October 29, 2015
BOARD OF COUNTY COMMISSIONERS
ORANGE COUNTY, FLORIDA

ADDENDUM NO. 5
IFB NO. Y15-771 PH
ORANGE COUNTY SOUTH WATER RECLAMATION FACILITY
PHASE V IMPROVEMENTS

DESIGNED: EW	PROJECT NO. 180761
DETAILED: DLP	C-25 SHEET 79 OF 364
CHECKED: CE/DA	
APPROVED: WDM	
DATE: JANUARY 2015	
ENGINEER OF RECORD: WILLIAM D. MARSHALL, PE FLORIDA LICENSE NO.: 66282

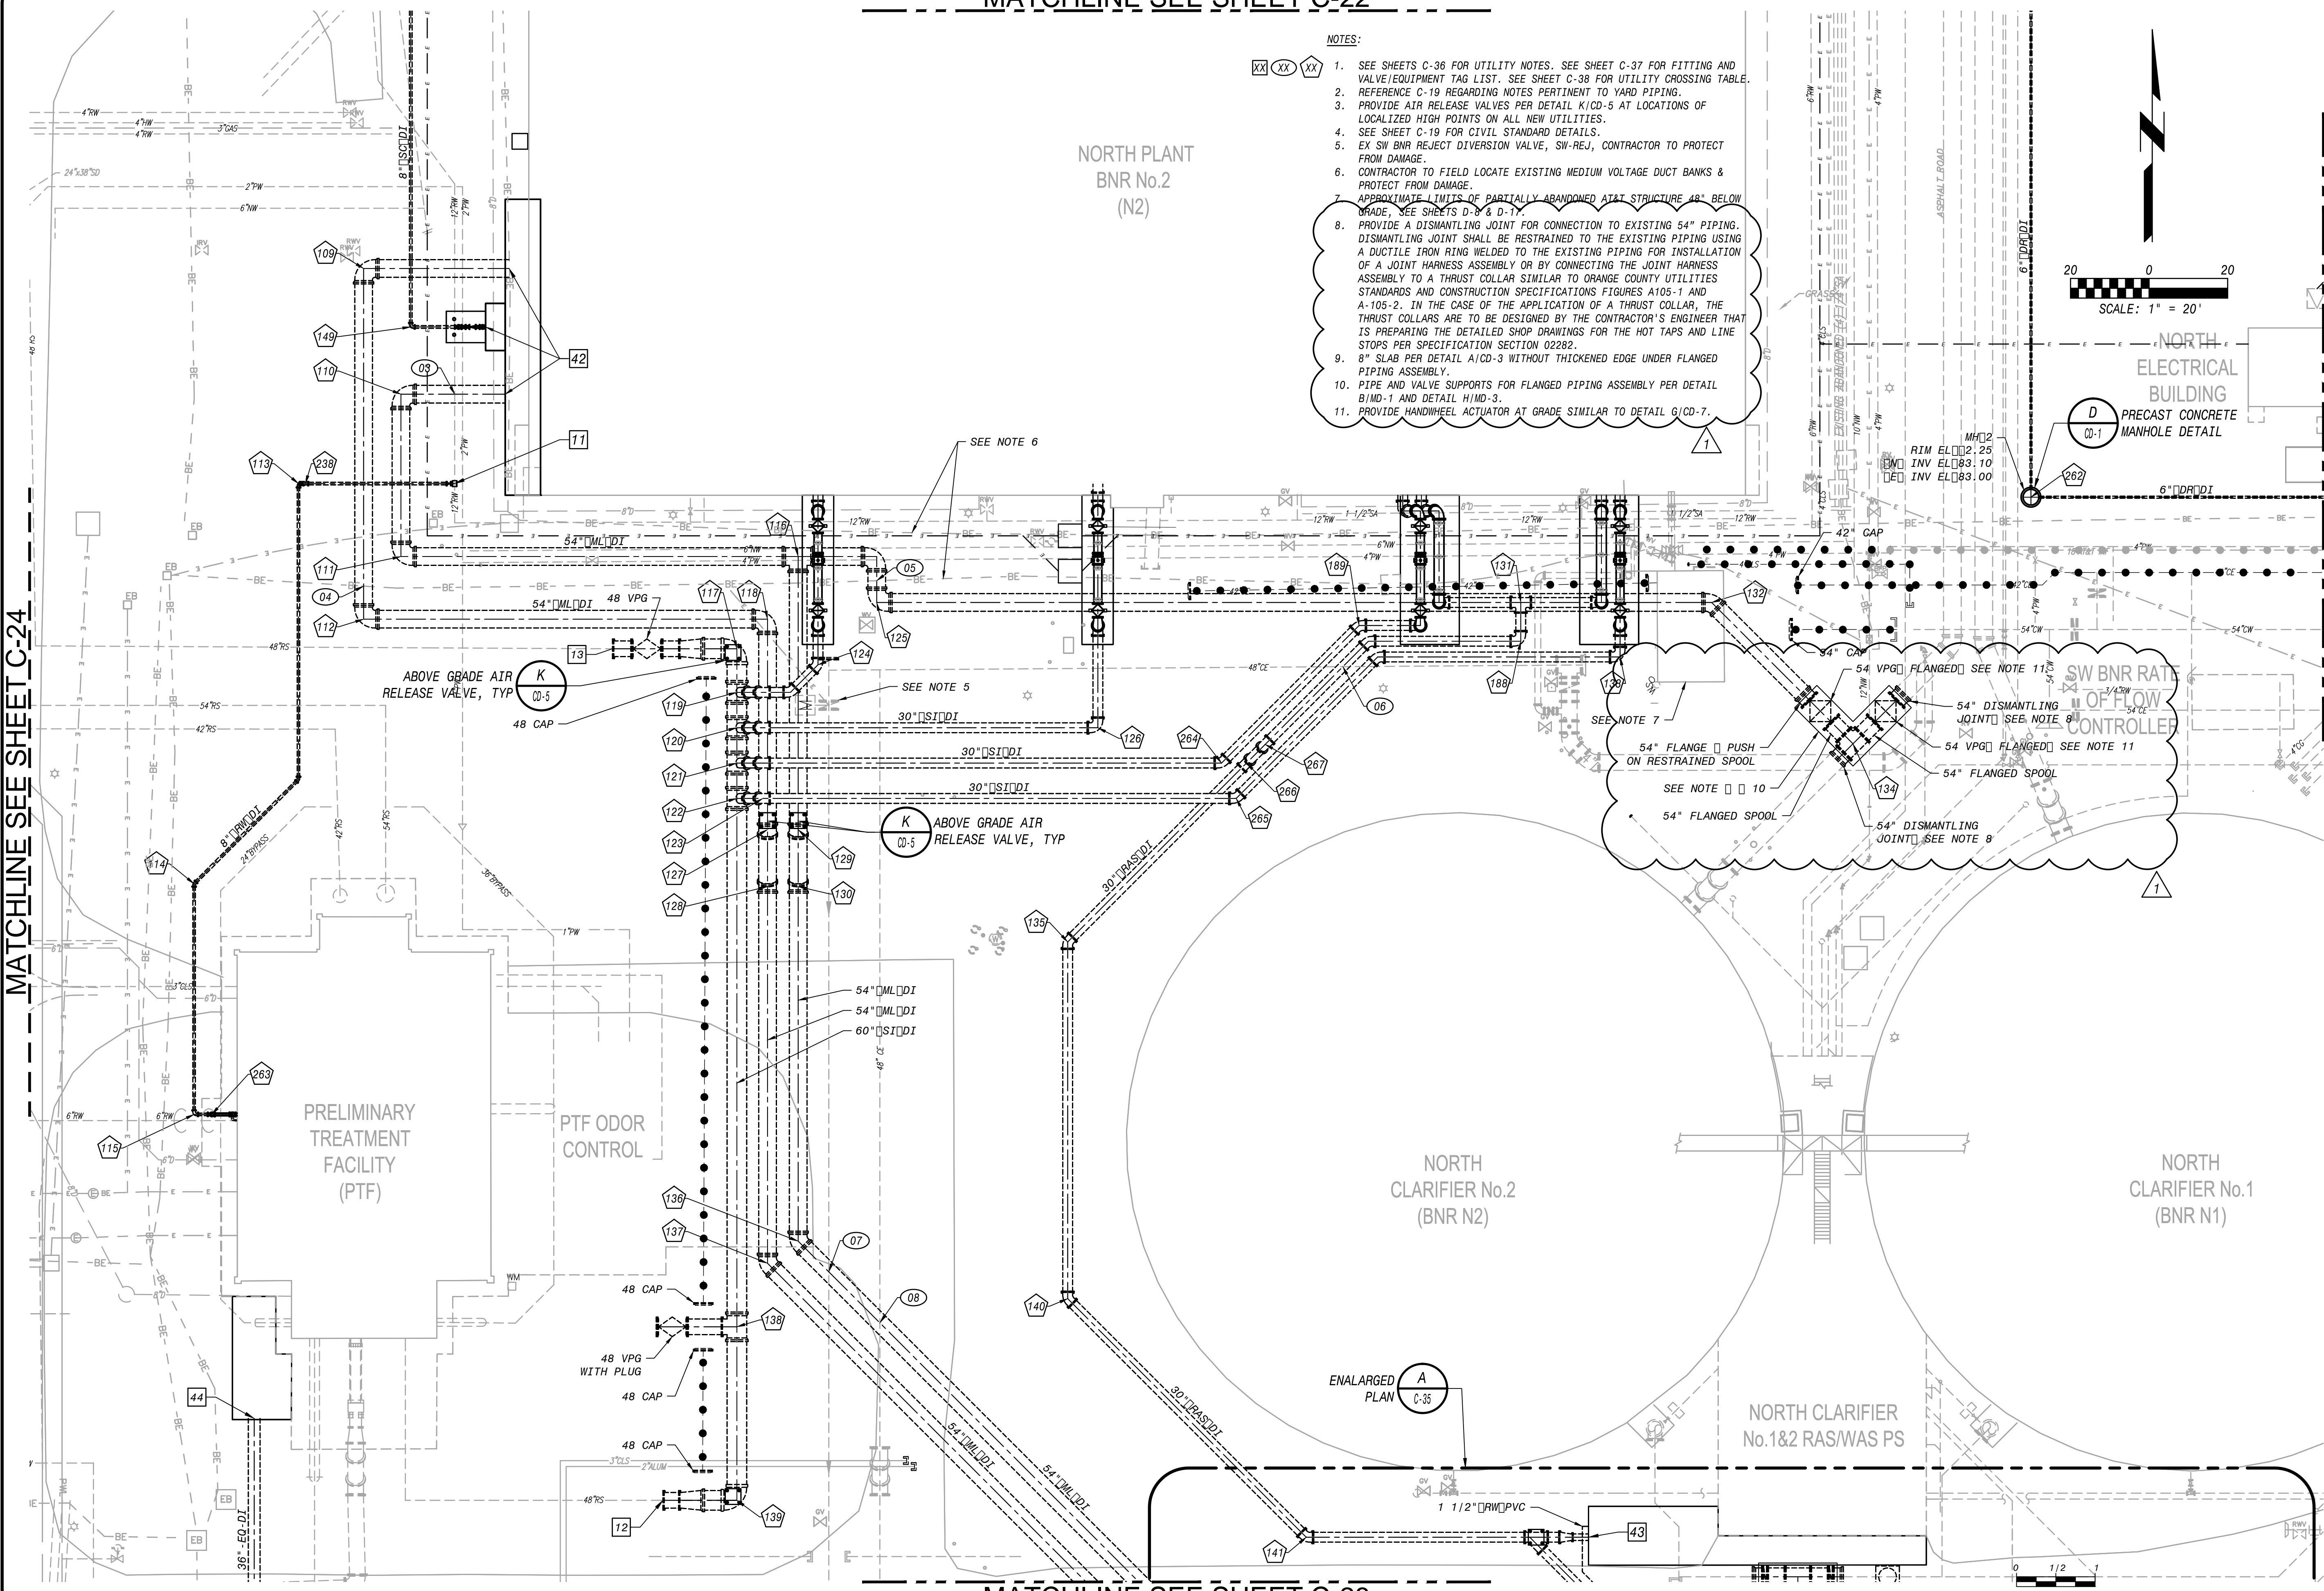
2. Sheet C-25: Replace Sheet C-25 in its entirety with the attached Sheet C-25 issued as part of this addendum.
3. Sheet C-28: Replace Sheet C-28 in its entirety with the attached Sheet C-28 issued as part of this addendum.

25. **Sheet C-25, Spec 01143, 1.5, d, Connection of 54" MXL to North Clarifier No. 2 Influent Line, please detail the connection at this location for the following reasons:**

Please reference Drawing C-25 (Attachment). Regarding this question the following specifications are revised as noted in Part B of this Addendum;

Please reference Drawing C-25 (Attachment). Regarding this question the following specifications are revised as noted in Part B of this Addendum;

Please reference Drawing C-25 (Attachment).

CIVIL
 YARD PIPING
 GRID 7

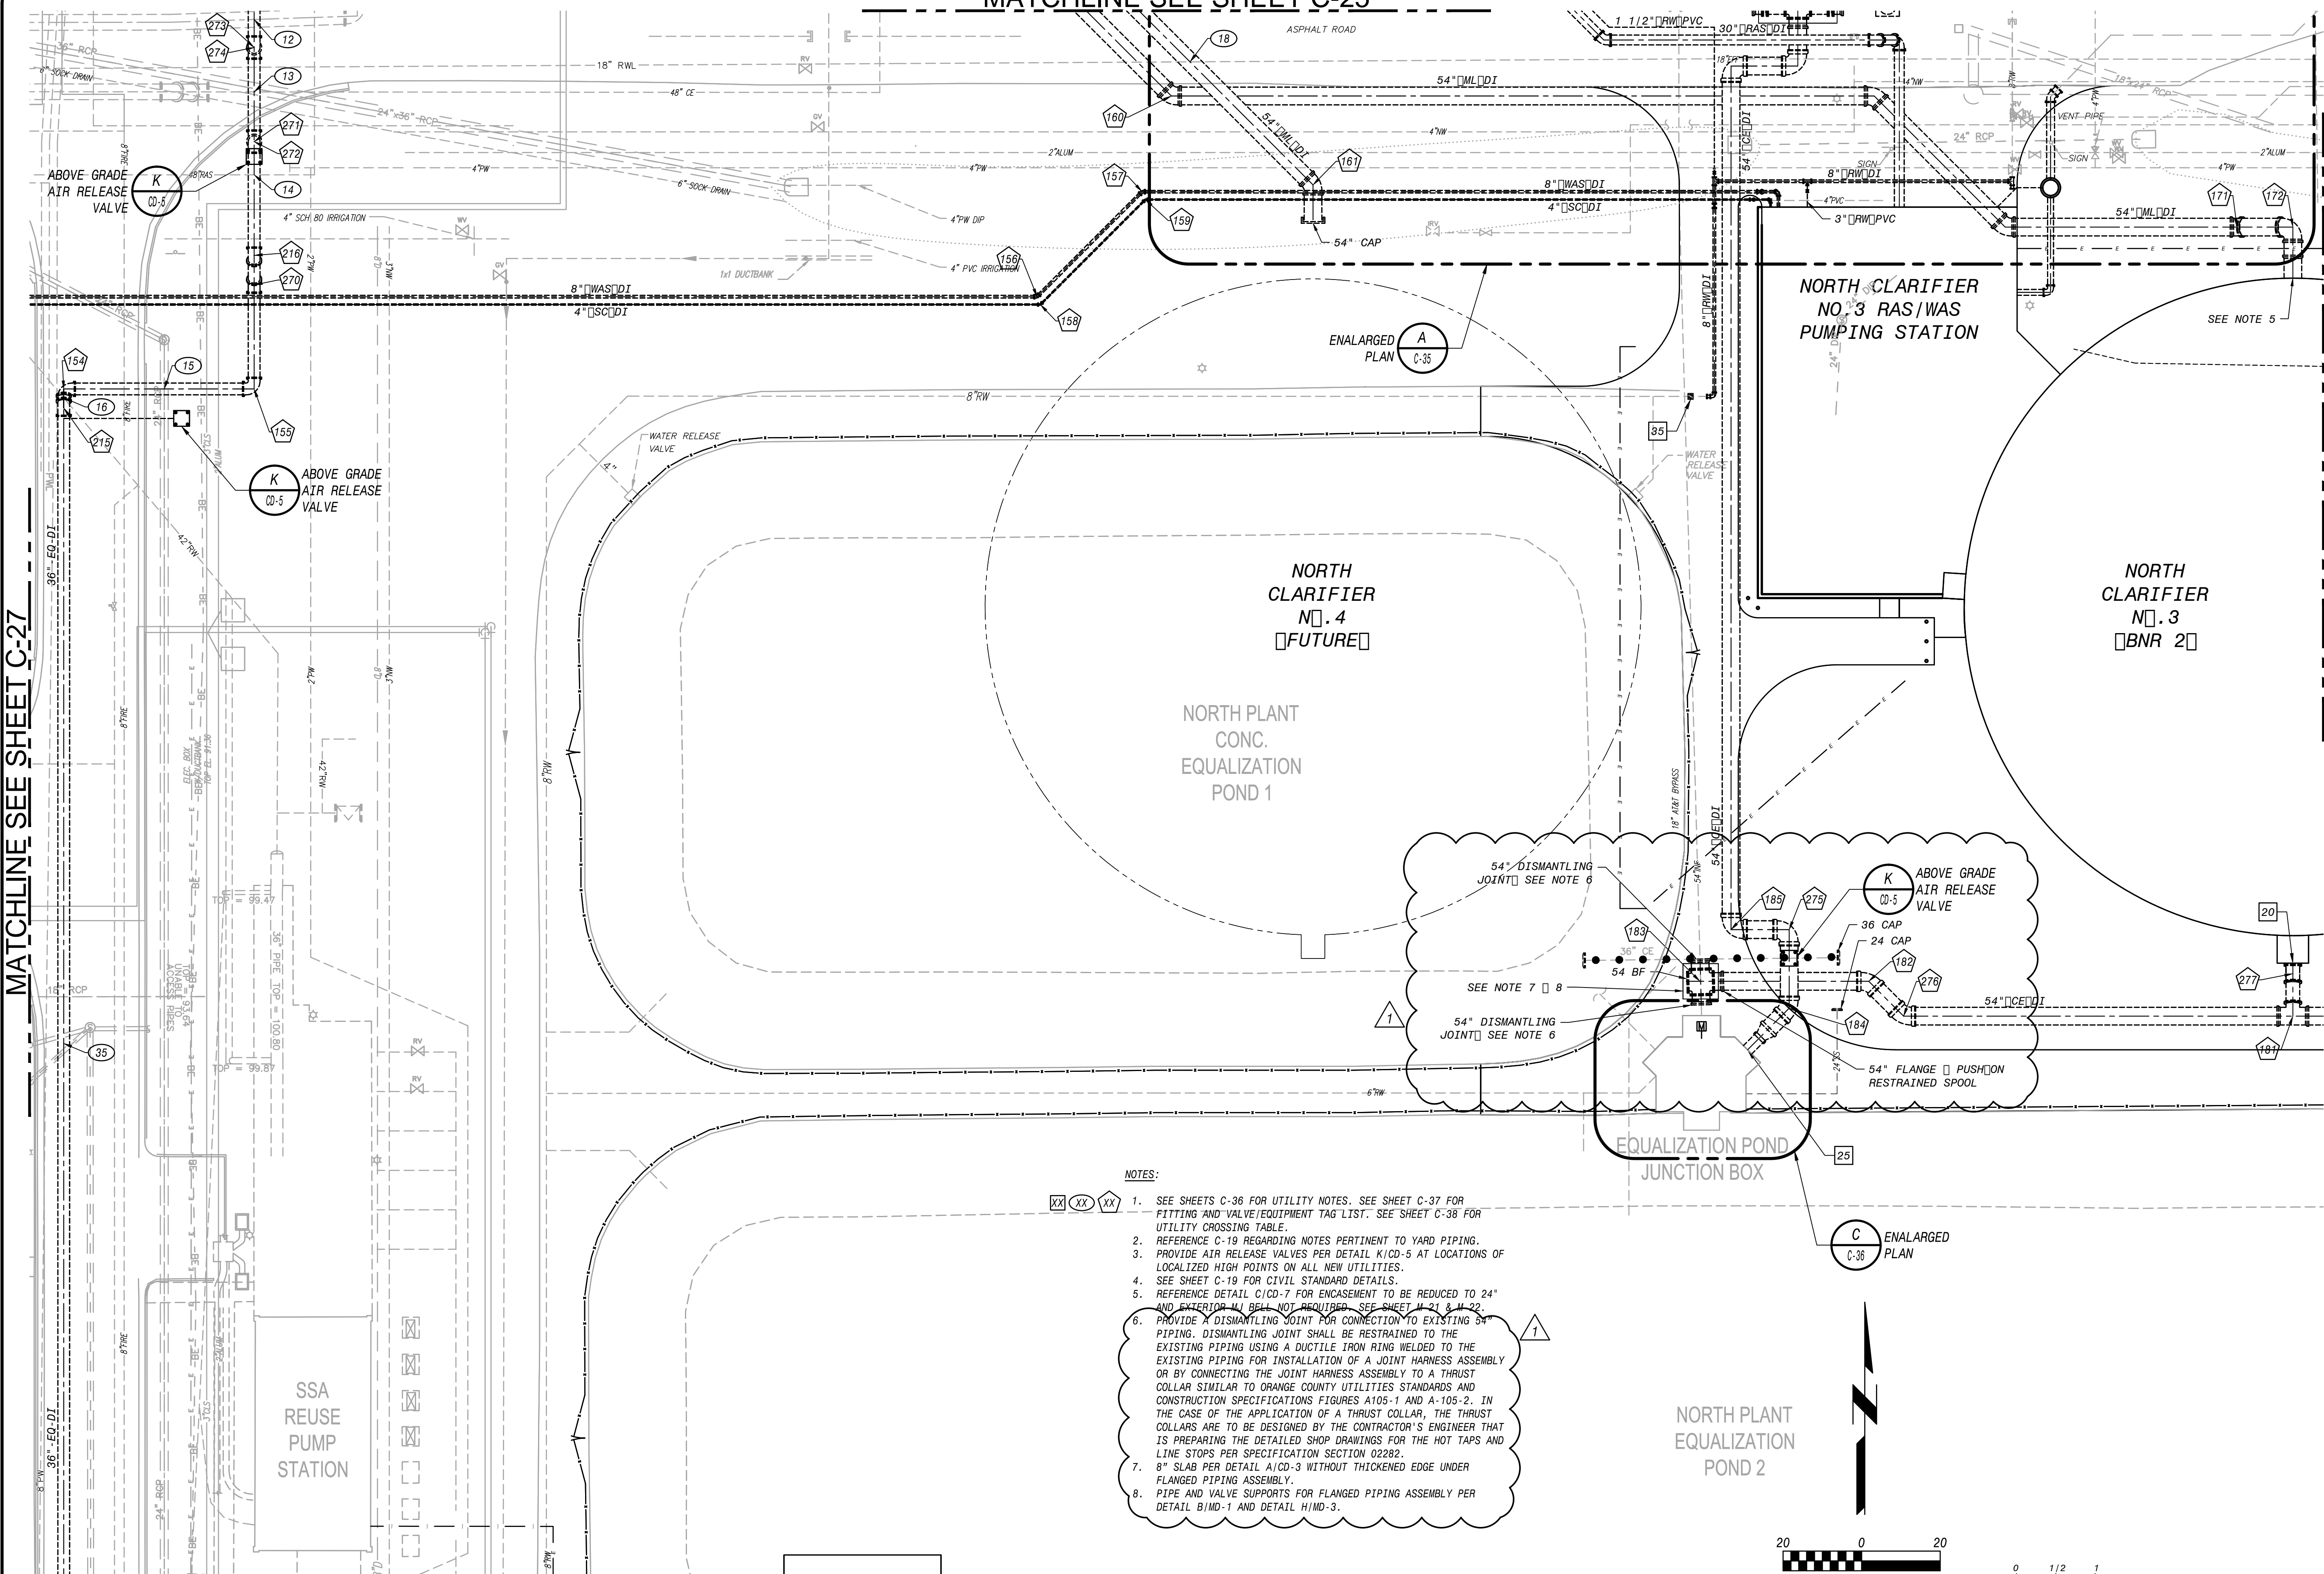
36. Sheet C-28, References Utility Note 24, and Spec Section 01143 1.5, f., please see below for comments:

37. Please confirm that Sheet C-28, Call out 181 should be a 54"x42" Tee, not a 54" Tee as listed on Sheet C-37.

Please reference Drawing C-28 (Attachment). Regarding this question the following specifications are revised as noted in Part B of this Addendum;
